RHODE ISLAND DEPARTMENT OF TRANSPORTATION

I-195 Relocation – Contract 16 – Providence River Pedestrian Bridge

NOTICE TO PROSPECTIVE BIDDERS

ADDENDUM NO. 9 Prospective bidders and all concerned are hereby notified of the following changes in the Plans, Specifications, Proposal and Distribution of Quantities for this contract. These changes shall be incorporated in the Plans, Specifications, Proposal and Distribution of Quantities, and shall become an integral part of the Contract Documents.

IMPROVEMENTS TO INTERSTATE ROUTE 195 CONTRACT 16 VOLUME 2 RHODE ISLAND
 LOWER DECK DRAINAGE PLAN AND SECTIONS A130

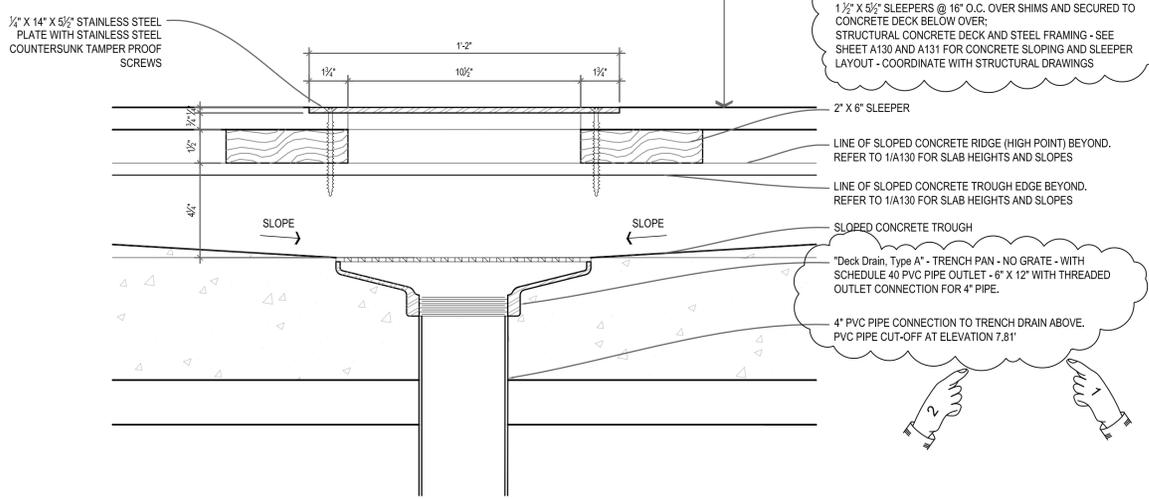
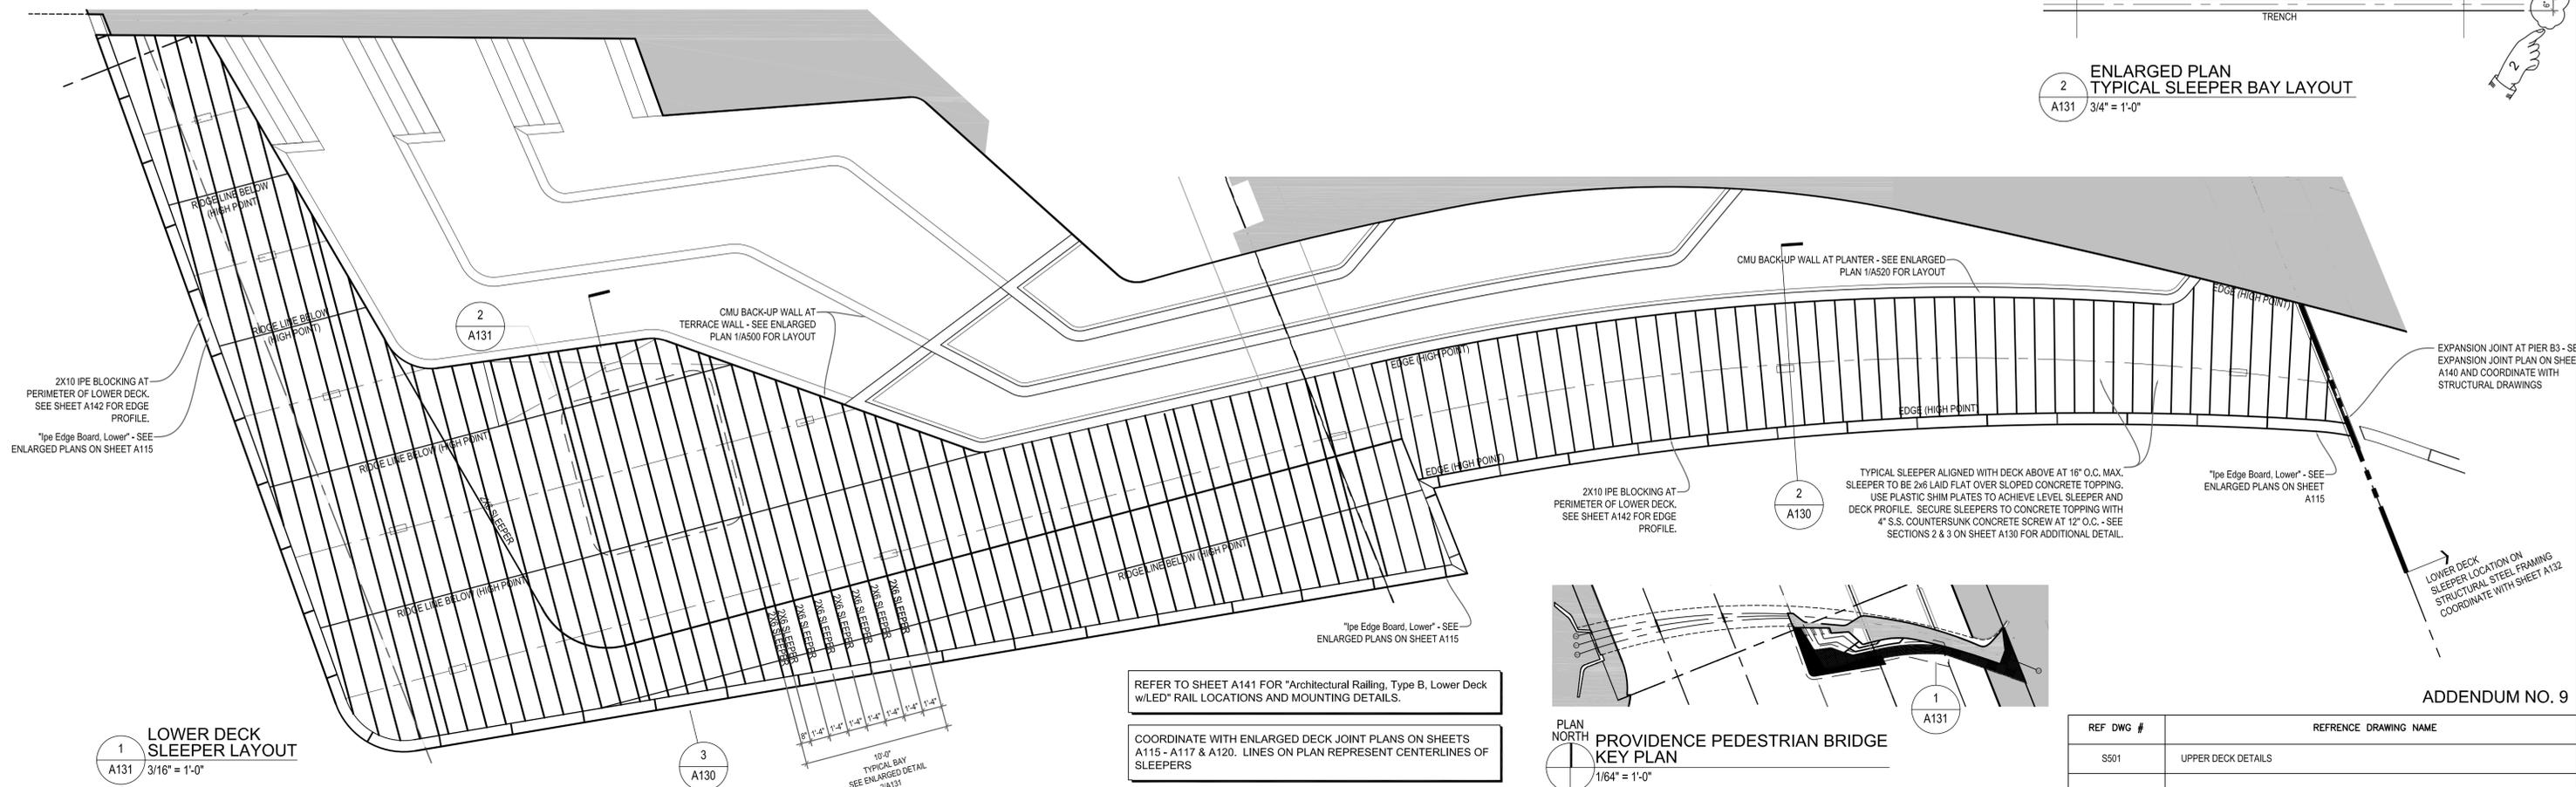
10. Sheet V2_019(R-1)
Delete Sheet V2_019(R-1) in its entirety and replace it with sheet V2_019(R-2) attached to this Addendum No. 9. The requirements for IPE deck hardware have been updated. Deck drains have been added.

5
 A532
TYPICAL PIER PLAN
NEW GRANITE CAP AT EX. COLUMN REMOVAL
 1" = 1'-0"

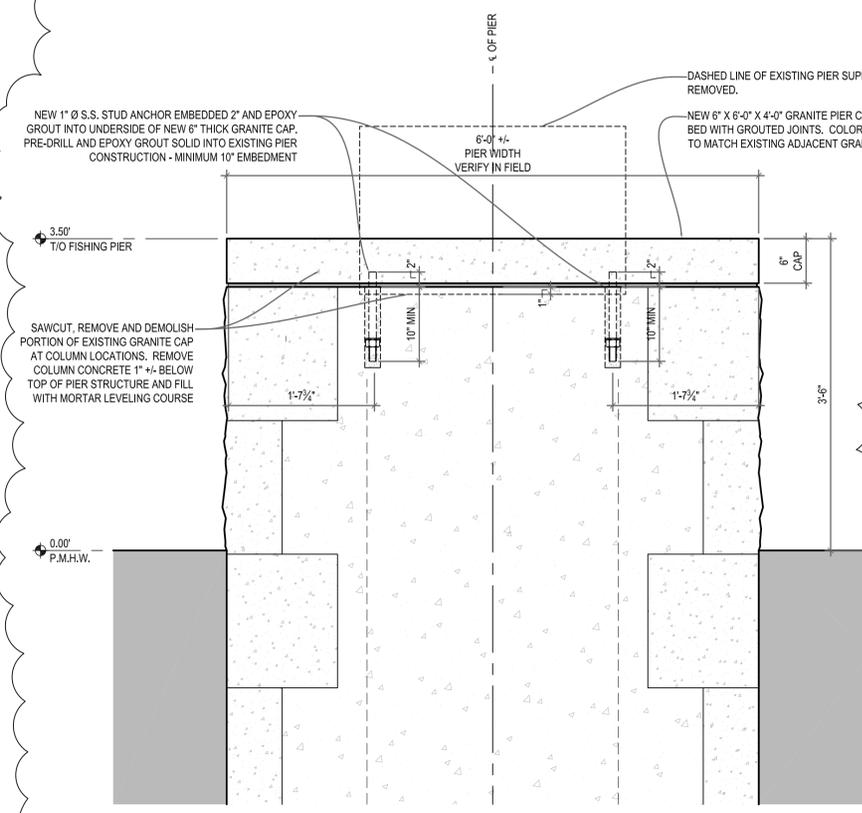
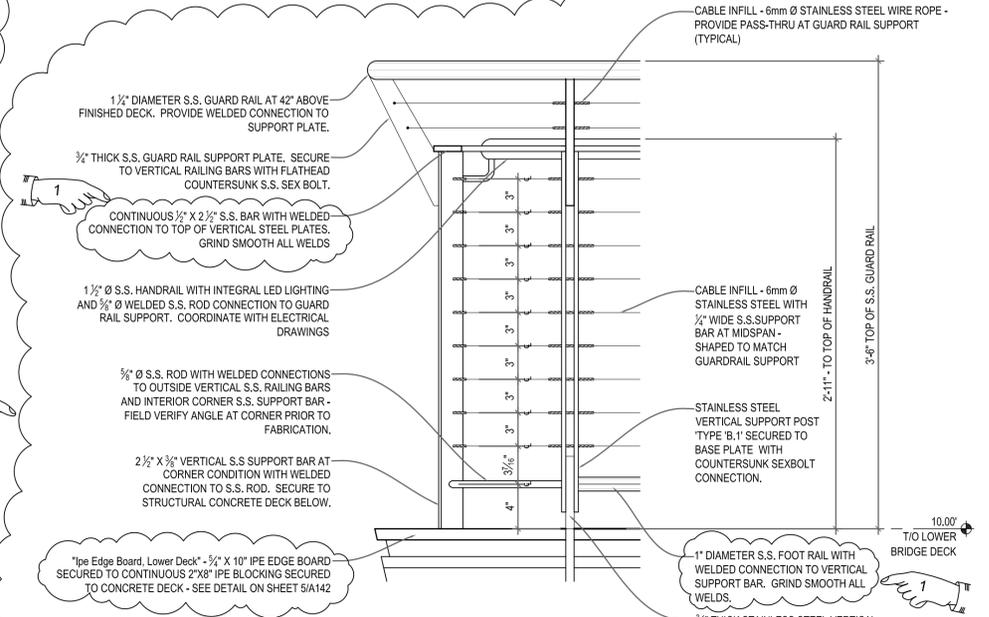
34. Sheet V2_068A(R-1)
Delete Sheet V2_068A(R-1) in its entirety and replace it with sheet V2_068A(R-2) attached to this Addendum No. 9. A detail and notes for the new granite cap at columns have been added. The requirements for IPE deck hardware have been updated.

1 SCHEMATIC STEP FOOTING SECTION
SCALE 1/2" = 1'-0"

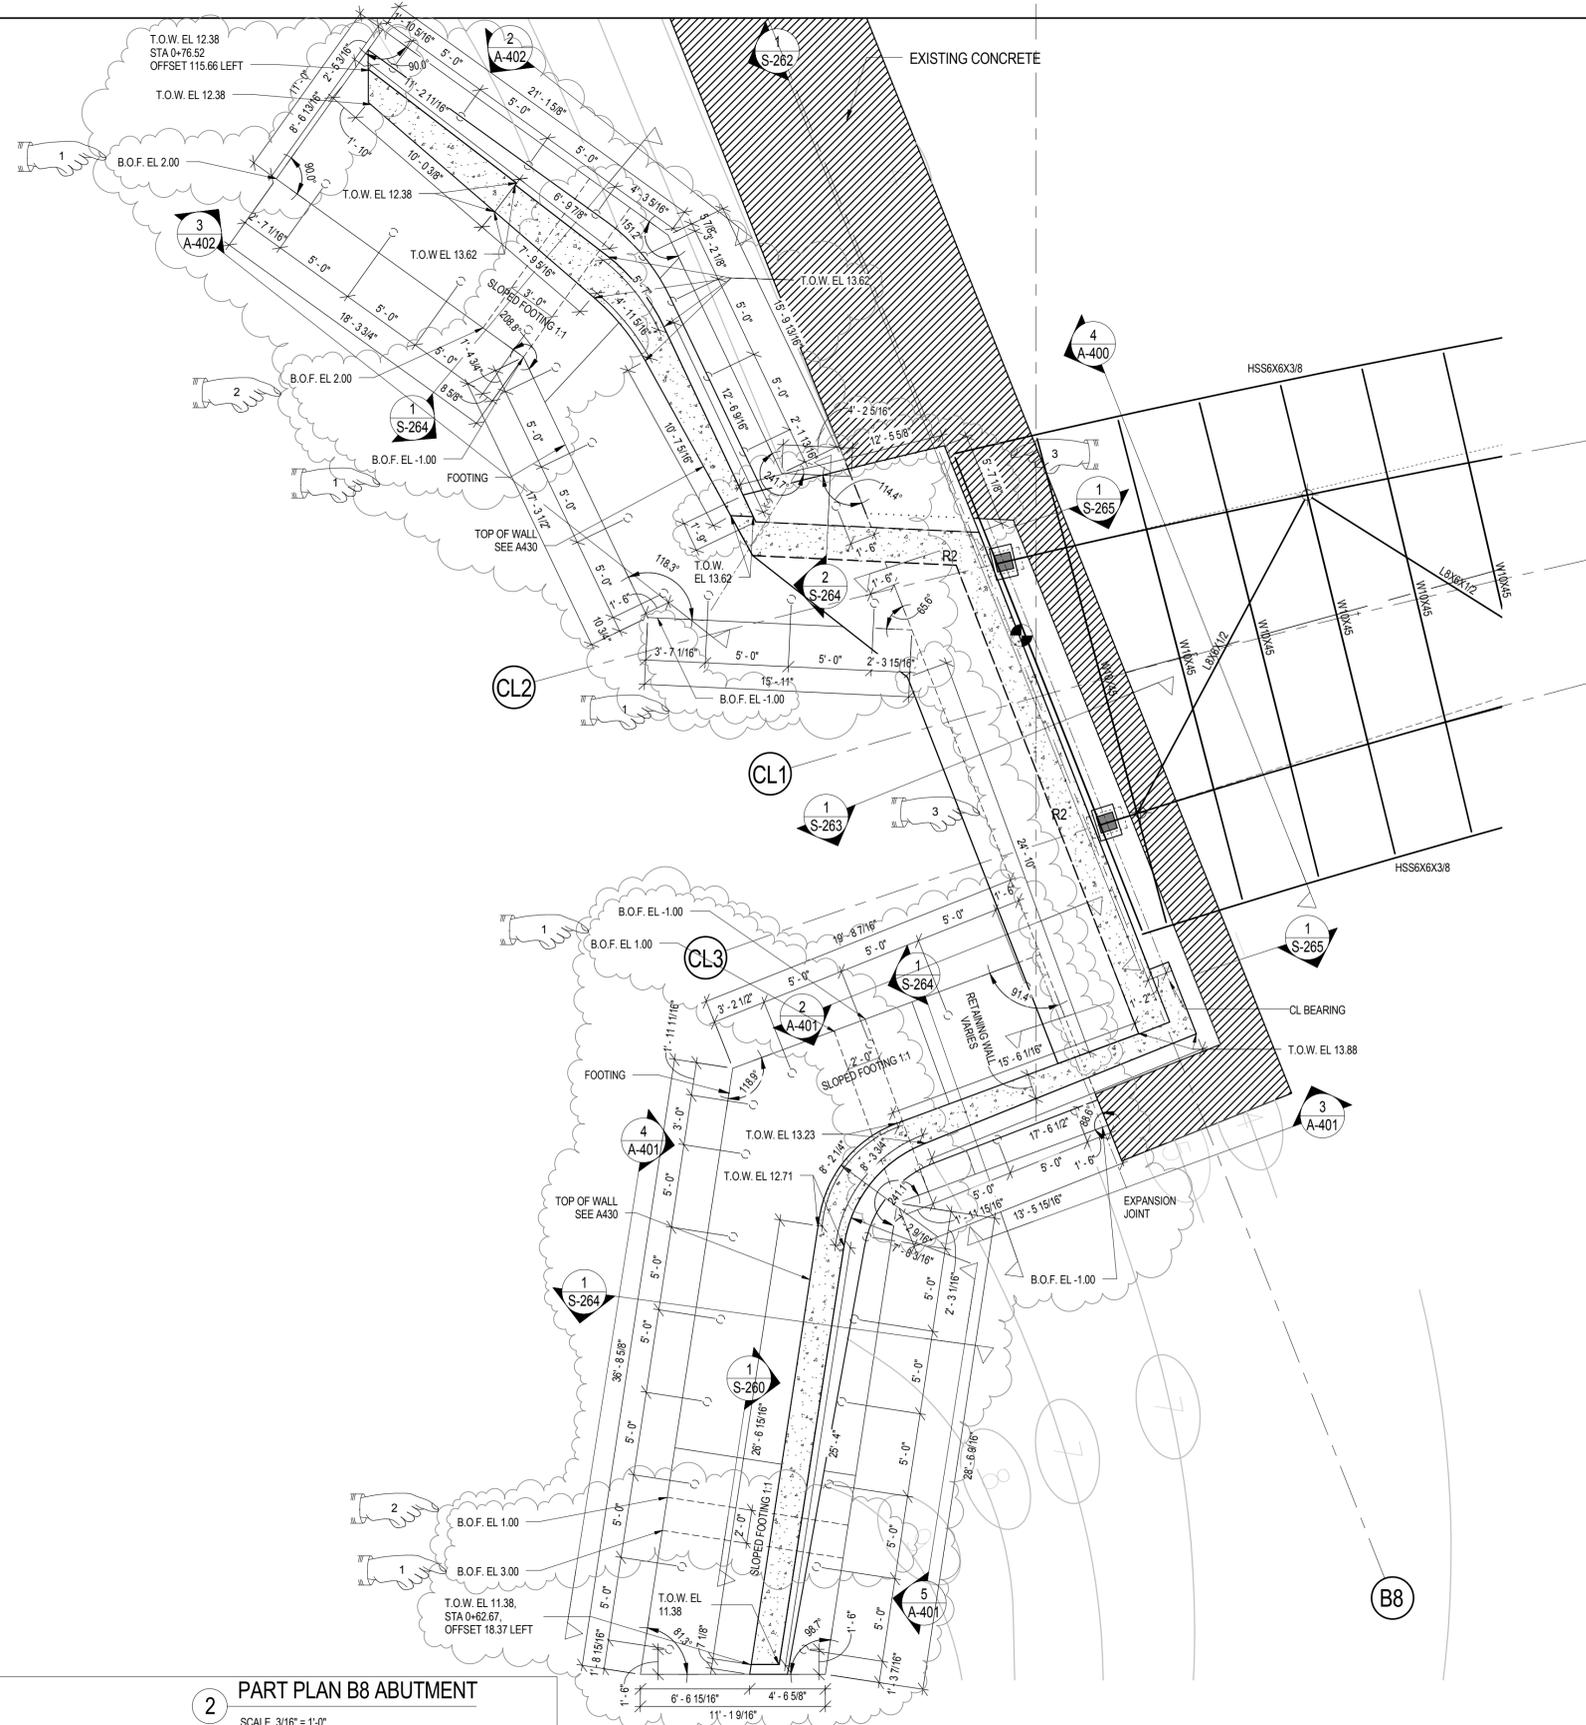
Question: Sheet 117 of 163 - section 2 shows a cantilever slab over the wingwall. Is this the approach slab? Please clarify the limits of the approach slab.

36. Sheet V2_113(R-2)
Delete Sheet V2_113(R-2) in its entirety and replace it with sheet V2_113(R-3) attached to this Addendum No. 9. The approach slab has been dimensioned.

Revised Answer: The limits of the approach slab will be clarified under addendum 9. The cantilever slab is integral with the approach slab, however the cantilever section will be paid for under 808.1501. See addendum 9.
